Herring Road Urban Activation Precinct

CITY OF RYDE

August 12, 2014

Executive Summary

Figure 1 - Bicycle Master Plan

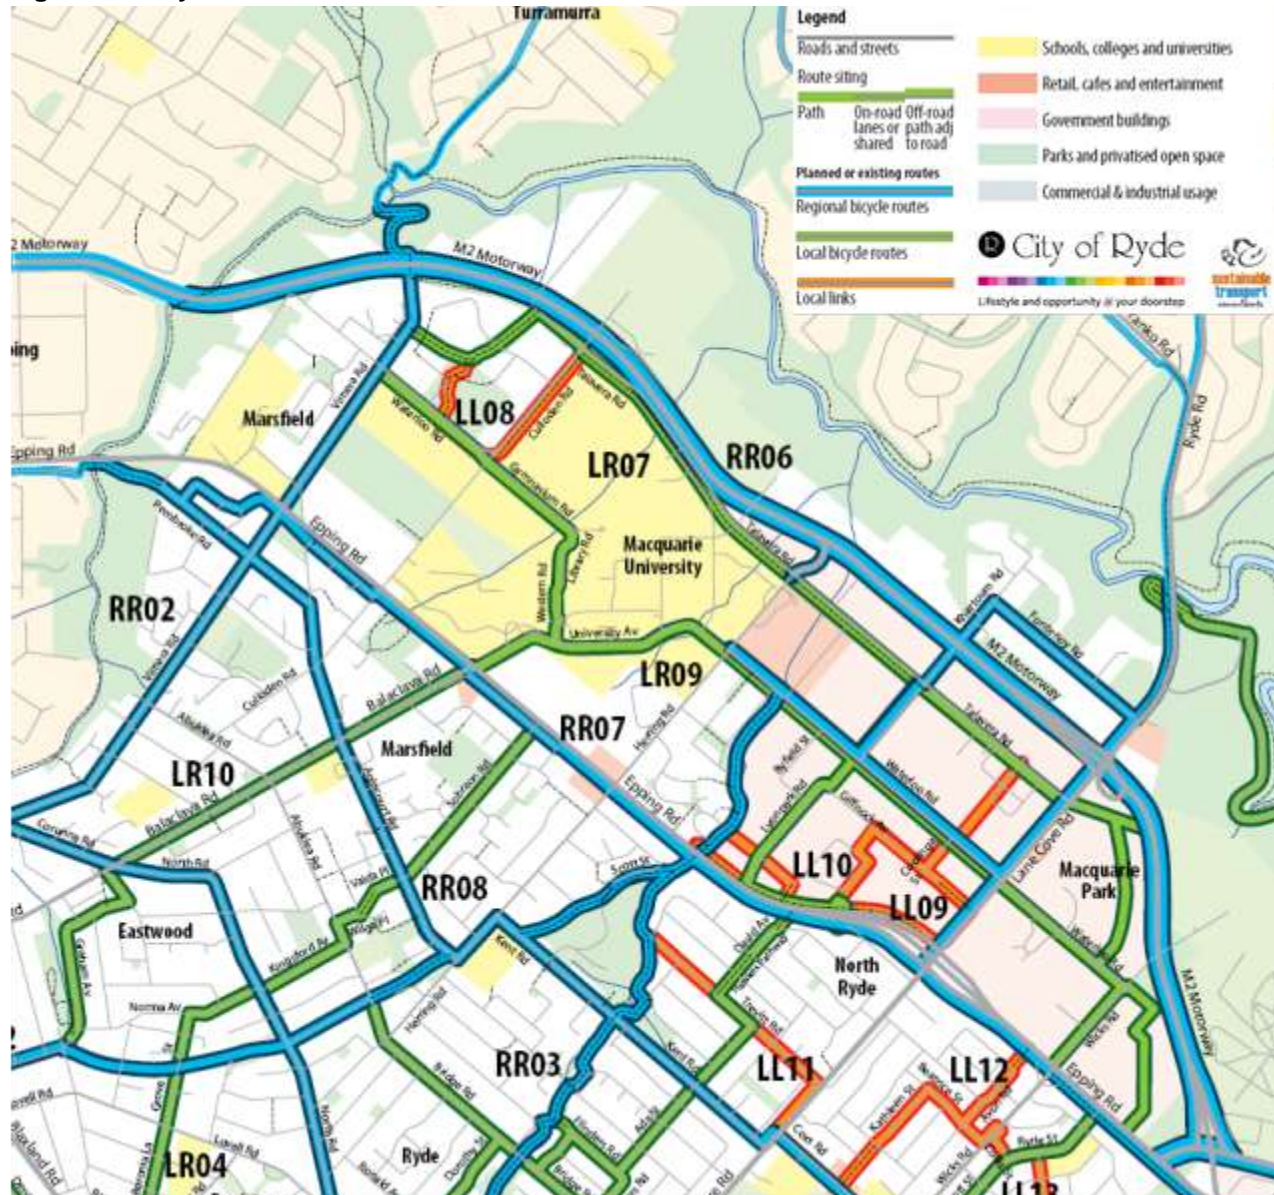
The UAP Planning Report does not appear to give any consideration to the *City of Ryde Bicycle Strategy (updated February 2014)*. Whilst existing paths are considered within the UAP Planning Report, this master plan identifies future intended links in around the area. An extract is provided below at Figure 1.

From the above Figure it can be seen that there are a range of different cycle routes surrounding the UAP area. The proposed Cycle network depicted in Figure 2 below fails to provide for new connections into the network. It does not connect into the proposed cycle routes along Waterloo Road, Epping Road (currently required as a condition on the Macquarie University Concept Plan), Balaclava Road, and other surrounding roads. These missing links could be imposed as part of the significant development uplift proposed by the UAP. It is also puzzling that the pedestrian networks detailed within the UAP as provided at Figure 2 do not align or reflect those shown within Figure 42 of the Planning Report, reproduced as Figure 3 below. In particular, the Department's attention is drawn to the links along Kikkiya Creek and between Peach Tree Road and Ivanhoe Place.

Figure 6- Building Heights under Amendment 1

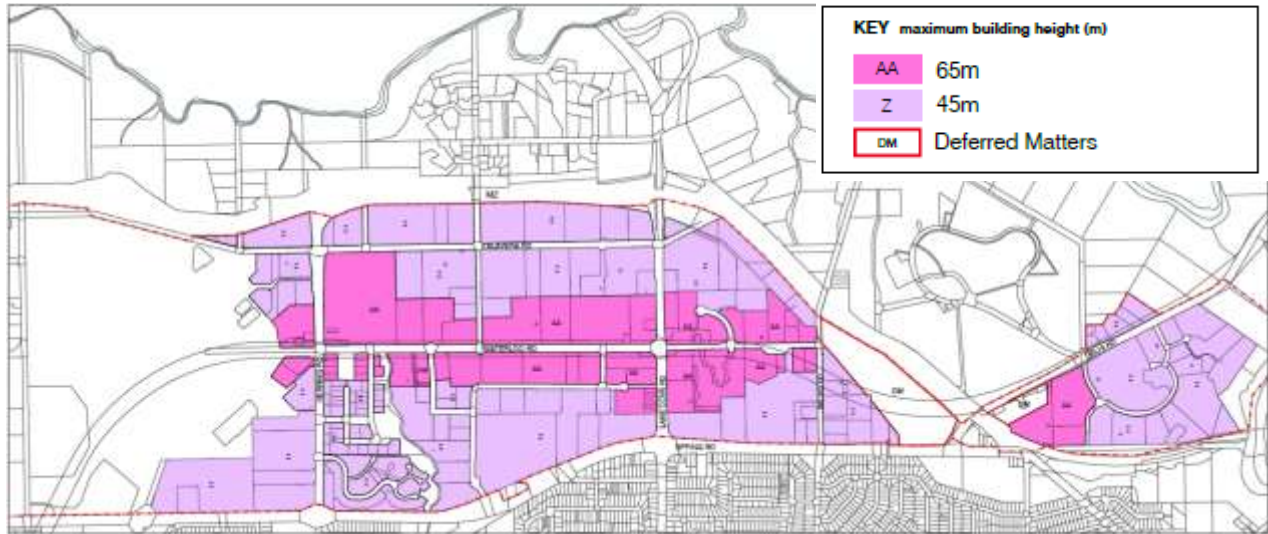
The following Figure 1, Figure 2, Figure 3 and Figure 4 detail the existing and proposed heights and FSRs for the UAP and immediate surrounds. It should be noted that no amendments to height or FSR outside of the Macquarie Park Business Corridor (MPBC) are proposed under Amendment 1 or Draft RLEP 2014. As such the FSR and heights for the areas outside the MPBC remain the same. Figure 8 and Figure 9 detail the heights and FSRs proposed under the UAP.

In light of the above, it is noted that there appears to be a disconnect in the heights and FSRs proposed for 157 Balaclava Road and 159-161 Epping Road. In particular, it is noted that it appears as though the FSR of 3.5:1 is not in the same location as the increased heights of 65m. This must be clarified.

Figure 12 - Macquarie Park Urban Form

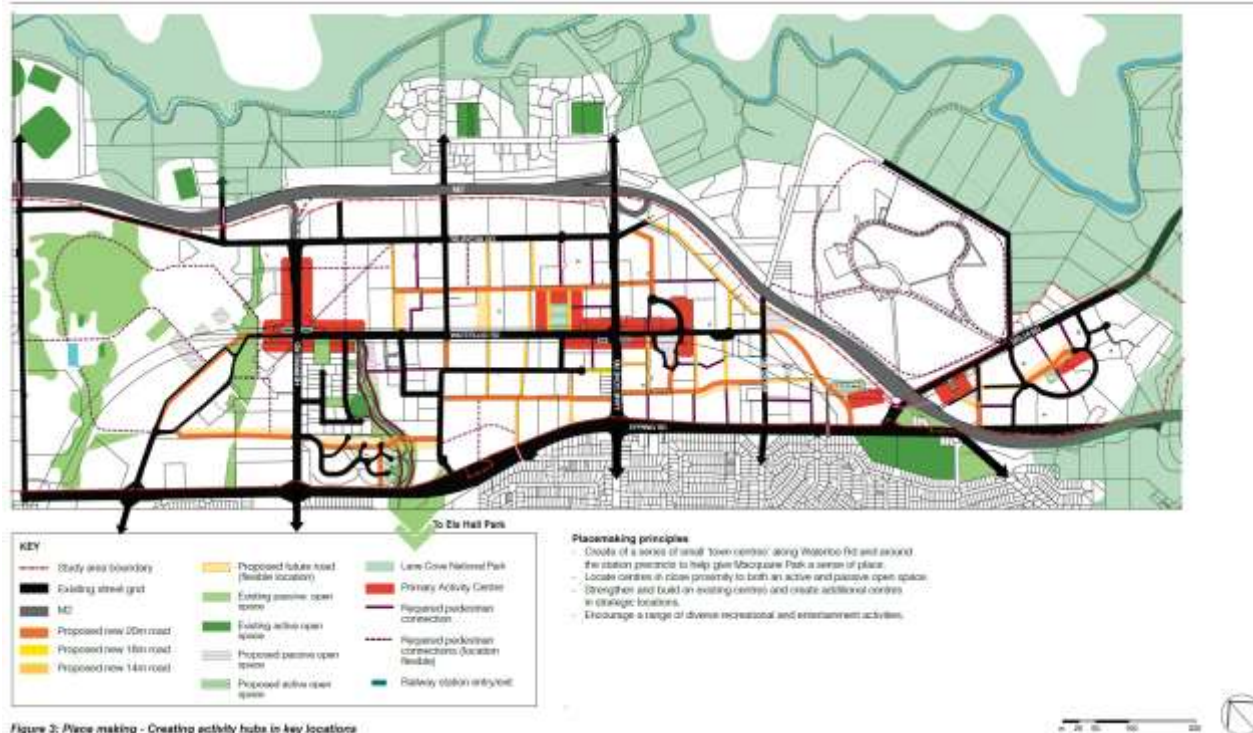
be achieved with zero side setbacks. Zero side setbacks also facilitate continuous all weather protection. What this means for the uses above ground level and nominal building depths has not been detailed within the submission. The stylised building envelope provided at Figure 52 of the UAP Planning Report appears to propose built to boundary podium style development that has significant depth. Presumably, this will not permit residential uses on the 6-8 storey street wall? It is noted that awnings are indicated on the detailed street section of Herring Road. Whether this is an appropriate built form for the entire length of Herring Road is questionable. This will be influenced by the active frontage location and whether it is feasible to have this for the entire length of Herring Road. Work undertaken as part of Amendment 1 is detailed at Figure 12 which details potential locations of active frontages.

However it must be recognised that it is unlikely that the entire length of Herring Road will be retail / commercial land uses. It is recommended that targeted areas for retail / commercial land uses be identified. This would then allow further resolution of the street setbacks to ensure that sufficient amenity is provided on the ground floor. As identified elsewhere in this submission, it is noted that some amendment / further resolution of the type of traffic, pedestrian environment and cycling infrastructure along Herring Road is required. This will then need to require a significant redesign of the treatment of Herring Road which may need for the widening of Herring Road to occur. This must be considered as part of any proposed setbacks.

Additionally, a zero setback on Waterloo Road may not be possible due to the Epping to Chatswood rail line which is located below Waterloo Road and constrains future development outside the railway stratum.

Figure 4.1: UAP Street Network Compared to LEP 2013 Draft (Amendment 1) Street Network

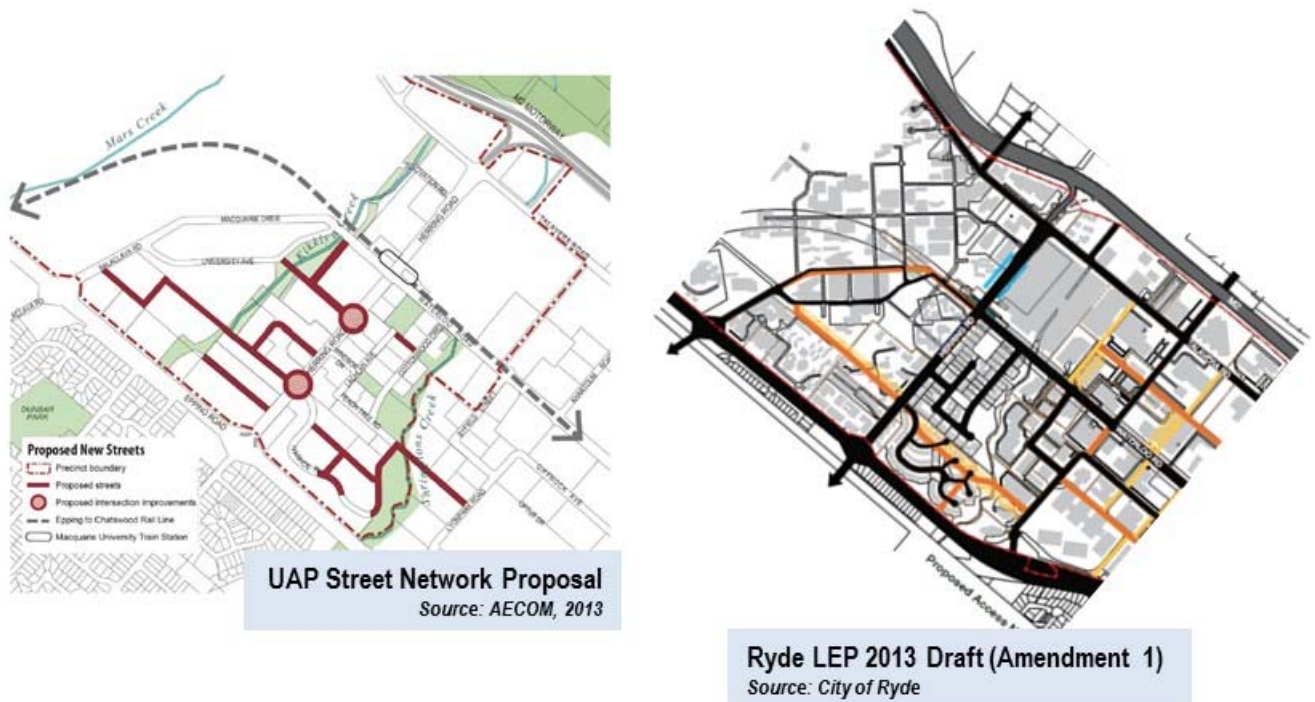
The proposed local street network in the UAP Planning Report is compared to the street network in the current Ryde LEP 2013 Draft (Amendment 1) in Figure 4.1.

It is unclear why the UAP proposal is to make this road one-way eastbound only and there would be significant benefits of making this link two-way to reduce pressure on Waterloo Road for local trip making. Similarly, it is unclear why the link from Cottonwood Crescent to Lachlan Avenue needs to be one way. Rat running through this area would be minimal in the north-eastbound direction given the two right turns required to do this and the circuitous nature of the route.

Also, the extension of Ivanhoe Place with a new road along the creek to connect to Peach Tree Road was not envisaged in the LEP Amendment and there may be some alignment challenges with this link and its proximity to the creek.

The key difference between the LEP Amendment and the UAP street networks is that that LEP Amendment street network has a finer grained road system proposed for the area west of Herring Road and south of the Waterloo Road intersection. This fine grained network may still be achievable in this area as part of the development planning of specific sites.

Figure 1: 2031 Morning Peak Hour Volume Estimates

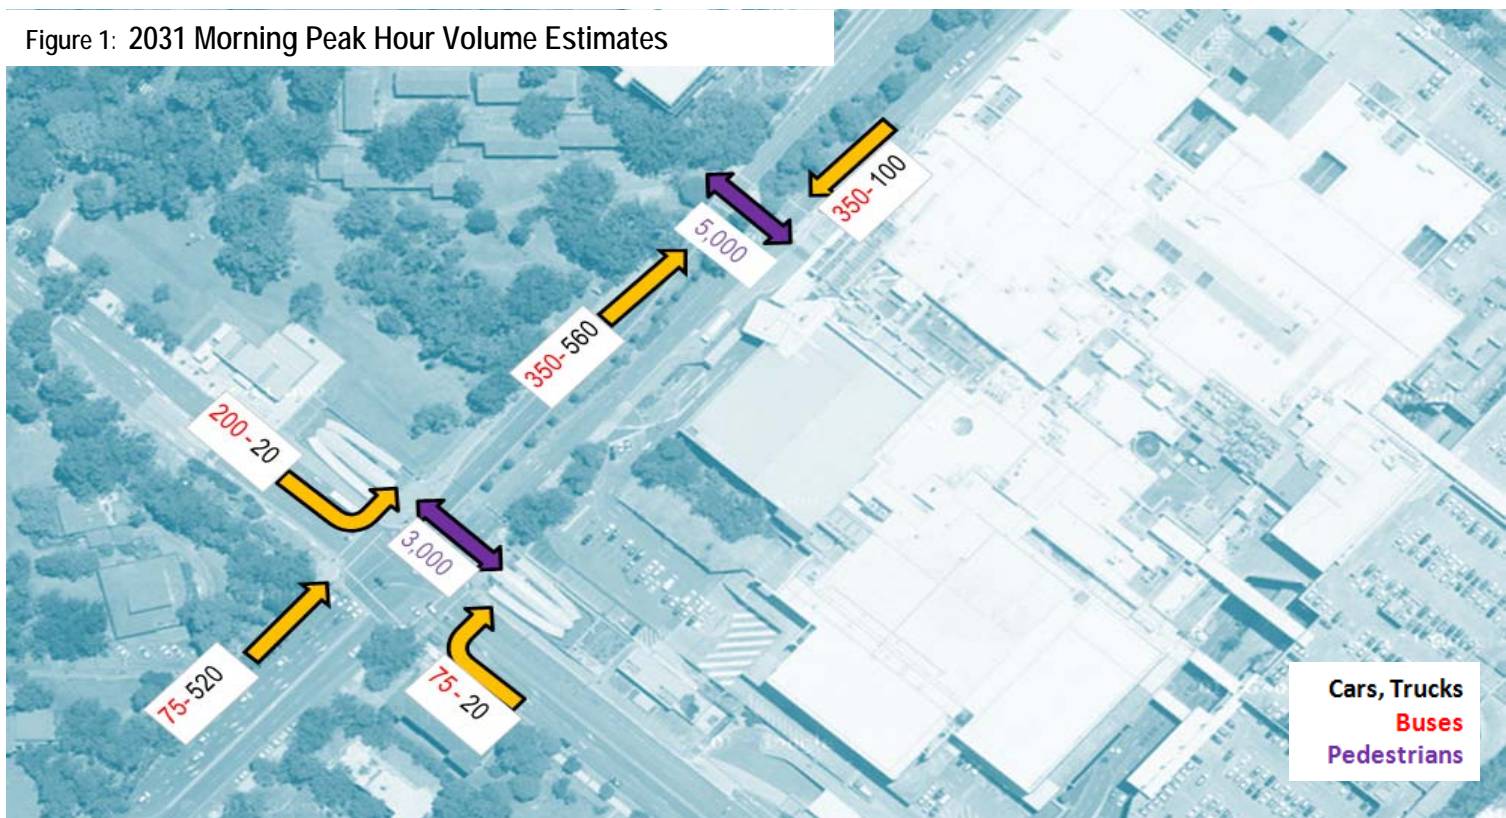
Figure 1 summarises these volumes as well as the traffic volumes through the area extracted from the 2031 Paramics Model.

In terms of a "logic check" on the estimated volumes, another 1,000, 000 m² of office space would equate to 20,000 peak hour trips, most of which would be accommodated on public transport given the limited traffic capacity able to be augmented into the current major road system. This does not even consider the growth in university trips and retail employment trips.

On the basis that an additional 8,000 trips can be absorbed into the road system, the extra 12,000 public transport trips when added to the existing 6,000 public transport trips to/from Macquarie Park matches reasonably well to the estimates made based on total demand in 2031.

The volume estimates presented in Figure 1 show significant conflicts between buses, cars and pedestrians at both the existing signalised pedestrian crossing and the intersection of Waterloo Road and Herring Road.

Figure 1 shows that approximately 350 buses per hour would be required to access the Macquarie Interchange; a significant increase from the 50 buses per hour currently using the interchange.
